MEMORANDUM

To: Design Review Board
From: Jon Regala, Senior Planner
Date: March 7, 2013
File No.: DRV13-00192
Subject: **PHASE I - LAKE STREET PLACE DESIGN RESPONSE CONFERENCE
150 LAKE STREET SOUTH**

LAKE STREET PLACE - PHASE I (KWM)
 150 LAKE STREET S
 KIRKLAND, WA 98033

SITE PLAN
 1" = 20'

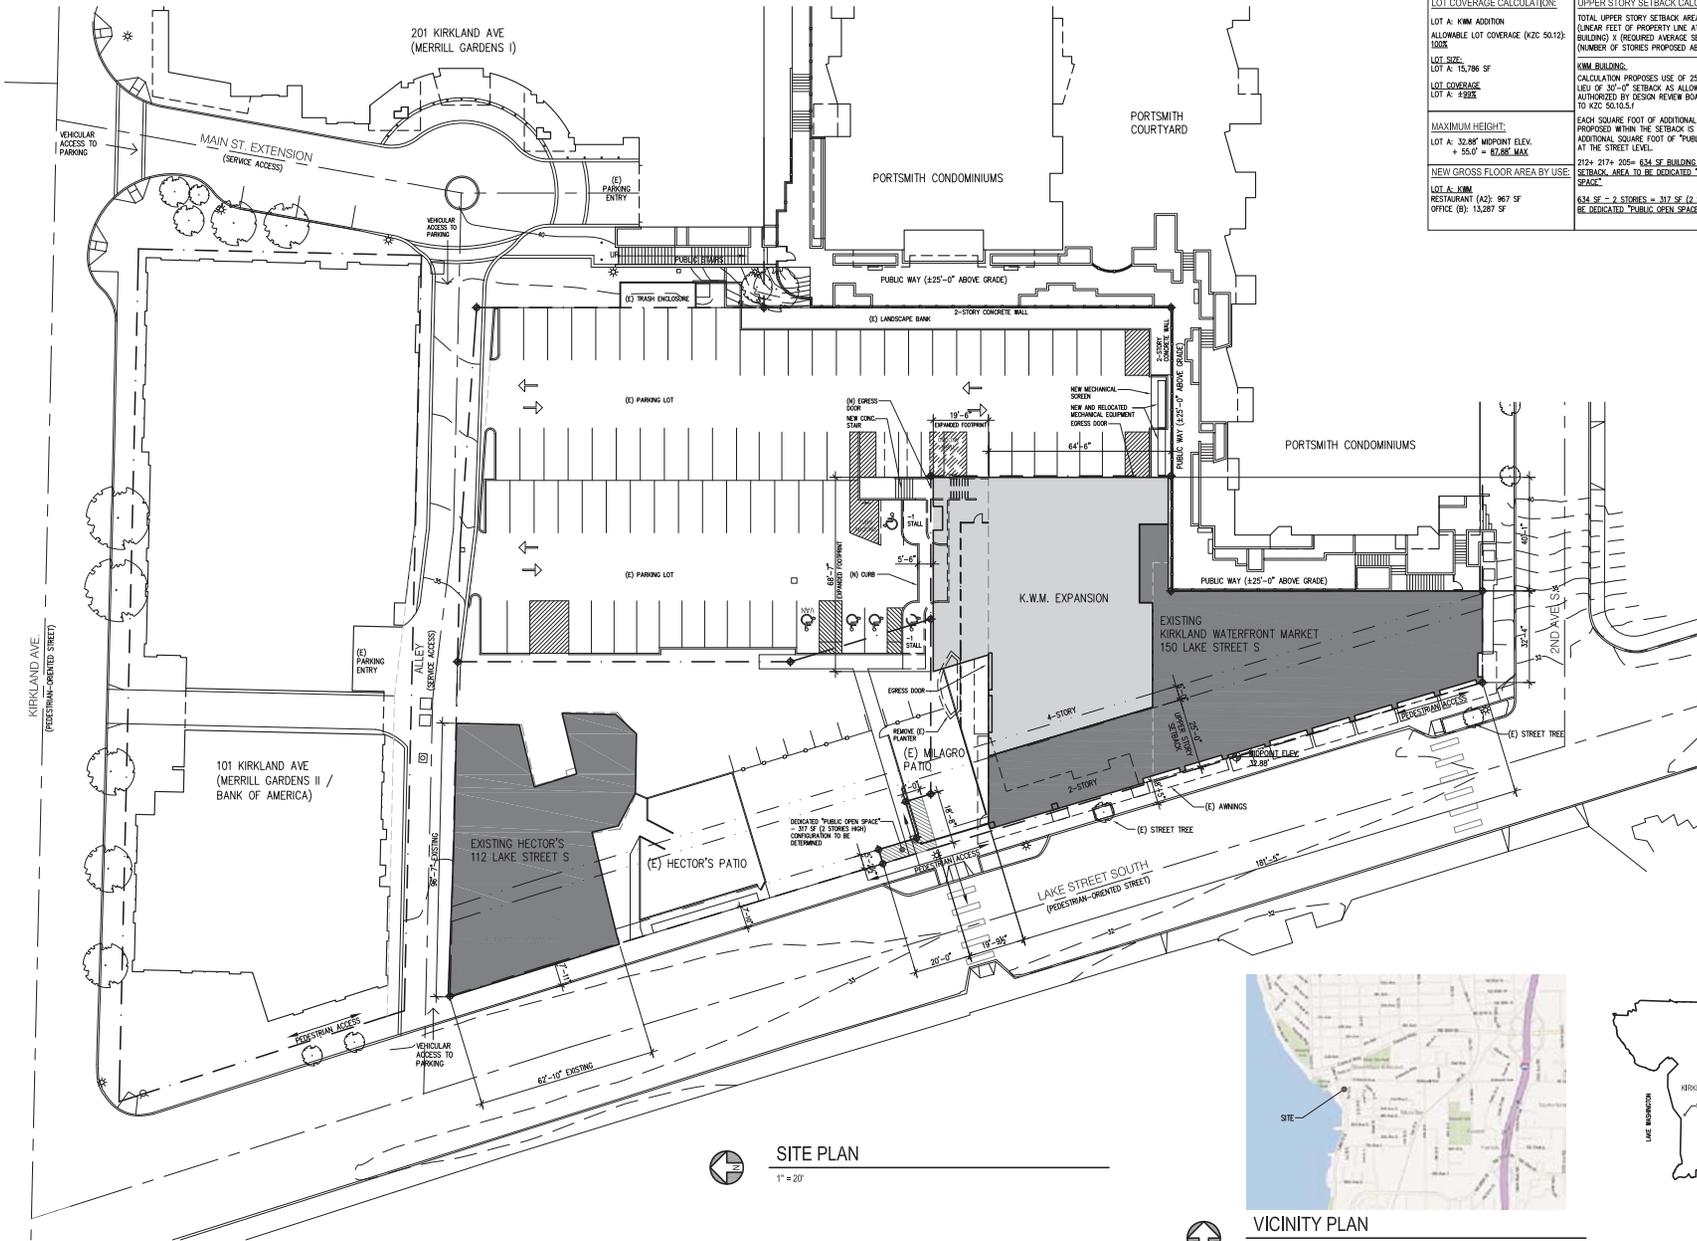
Lake Street - Portions of the 3^d and 4th story of the Kirkland Waterfront Market addition are proposed to extend up to 5' into the required upper story 30' setback from Lake Street. The applicant is requesting DRB approval to encroach into the setback pursuant to KZC Section 50.10.5.f in exchange for dedicating public open space at the street level.

The 3^d and 4th story encroach approximately 3.6' into the setback and the roof extends 5' into the setback. This equates to 634 square feet of building area within the 30' upper story setback. Based on this area amount, the applicant is required to dedicate 317 sq. ft. at the street level. The applicant is proposing to dedicate the required open space in the central courtyard approved for the overall project along the Lake Street frontage (see Attachment 2, Sheet 1.0). This request to extend into the required 30' setback was approved with the previous DRB decision.

While the location of the proposed public open space area makes sense (middle of the courtyard next to Lake Street), the DRB should review the 'L' shape configuration of the open space area and provide feedback to the applicant based on the applicable guidelines. See Section V.A.4 above. The applicant must demonstrate compliance with this requirement as part of any building permit.

ELEVATIONS

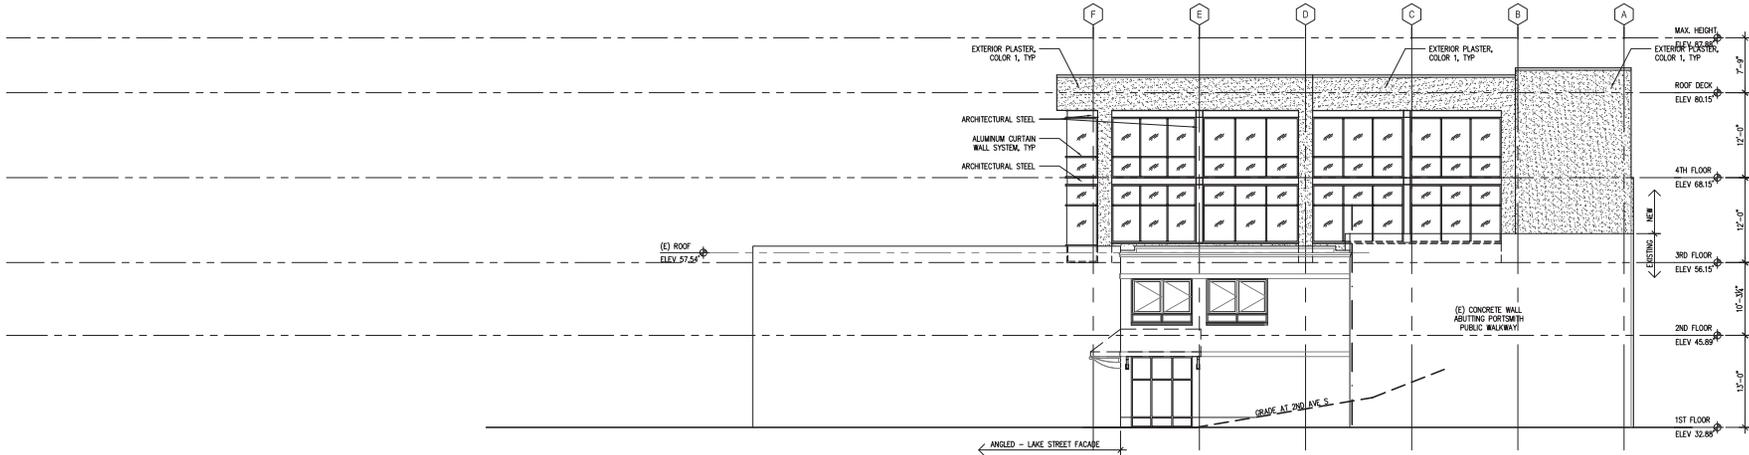
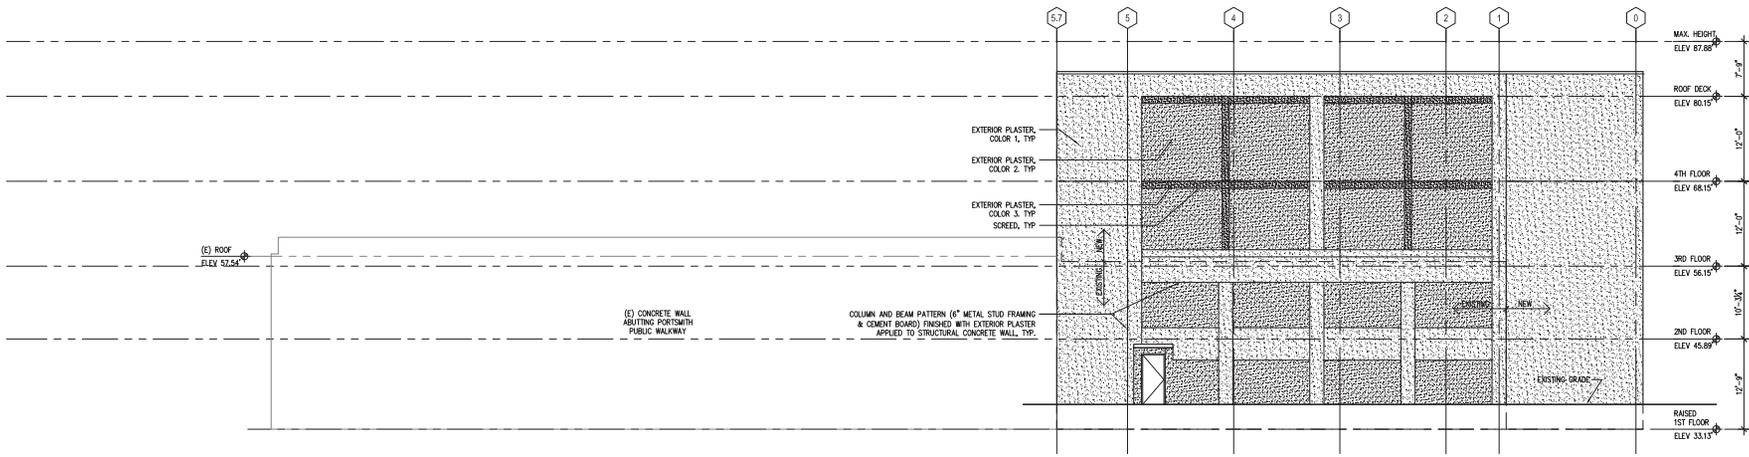
Windows are not proposed on the north and east facades since they will be eventually covered by the future building. At question is to what level should the north and east facades be designed given that compliance with the design guidelines is required and that the facades may eventually be covered up by a future project phase.

- *Confirm that no changes are needed at the west and south facades (previously approved).*
- *Determine what changes, if any should be made to the north and east facades based on the design guidelines topics listed below.*
 - *Blank wall treatment*
 - *Vertical and horizontal modulation*
